NUREG–0847
Supplement No. 15

Safety Evaluation Report

related to the operation of
Watts Bar Nuclear Plant,
Units 1 and 2

Docket Nos. 50–390 and 50–391

Figure 6.1 Divider Barrier Seal

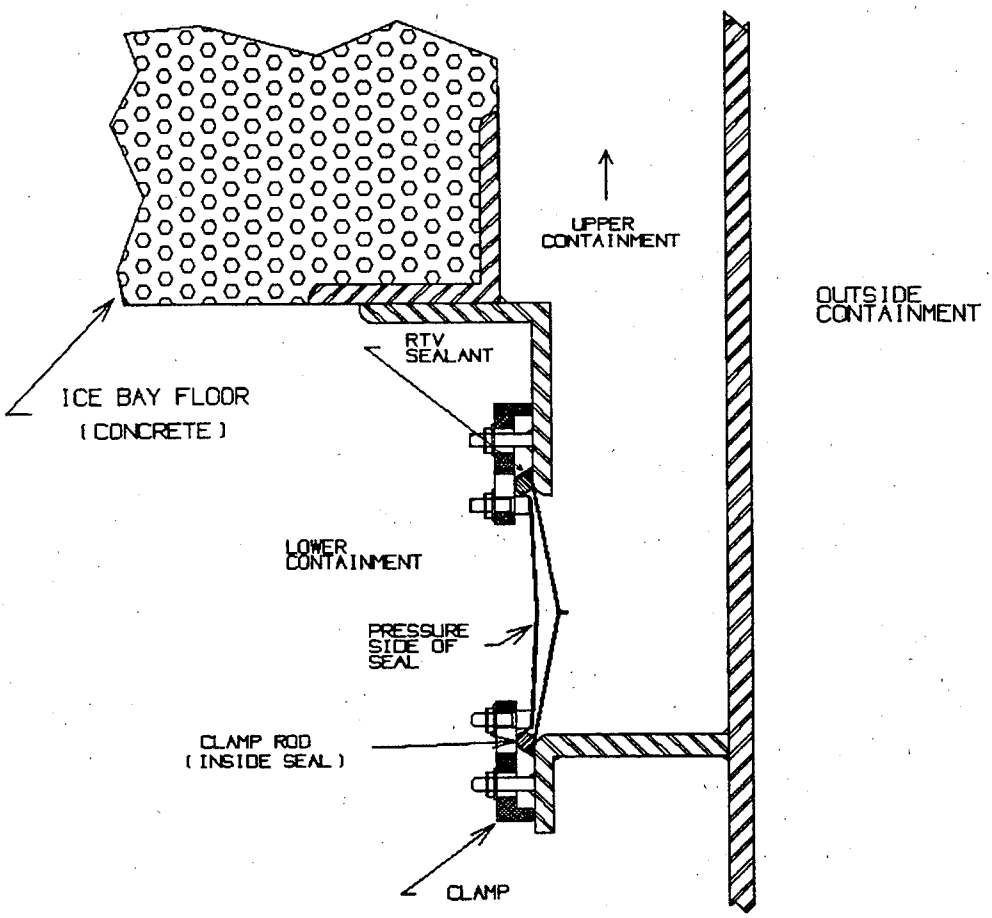
The cold-splice adhesive used in the installation of the material that replaces the removed specimens has been found to provide sufficient strength for LOCA integrity in the tested (unaged) conditions, but to be vulnerable to heat aging. As indicated above, its condition must, therefore, be monitored through additional unique periodic surveillance testing. Peel tests would be performed on test specimens at 18-month or 36-month intervals, the interval for each joint location being dependent on the initial peel test result for that location. The peel test procedure and recommended test interrvals are described in Presray Report No. PR16550, "Procedure for Cold Bonding Divider Barrier Seal Splice Joints." The staff reviewed the report while on site on February 23, 1995. The test specimens are not part of the actual divider barrier seal. They are specimens of material removed during the repair and are located near the seal at each splice joint.

The staff reviewed the information submitted by the applicant and concluded that a revised divider barrier seal surveillance program is appropriate for Watts Bar Unit 1. The tensile testing may be deleted based on the additional testing that demonstrates that the seal material, including the original vulcanized joints, is qualified for a 40-year life and DBA-LOCA. Additional peel tests on test coupons will be performed periodically to monitor the condition of the adhesive used in the cold-bond/bolted splices. The test frequency for the peel tests will be as recommended by the vendor.
